KION

Service Manual – Addendum 1999-11-15

External connections-label

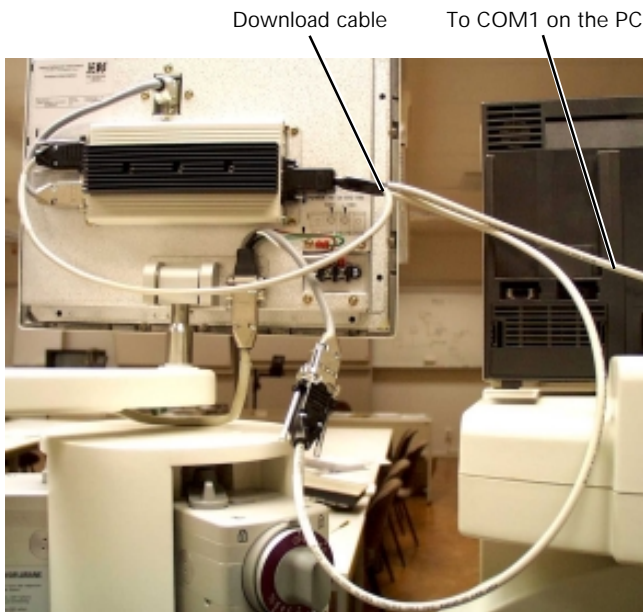
A label indicating the function of the external connection ports is attached close to these ports. Due to a printing error, the two MIB ports have been transposed on older versions of this label.

Correct information is that:

- The port to the left is MIB1.
- The port to the right is MIB2.

External connection labels with this printing error will be replaced as a corrective action included in Update 1999-09.
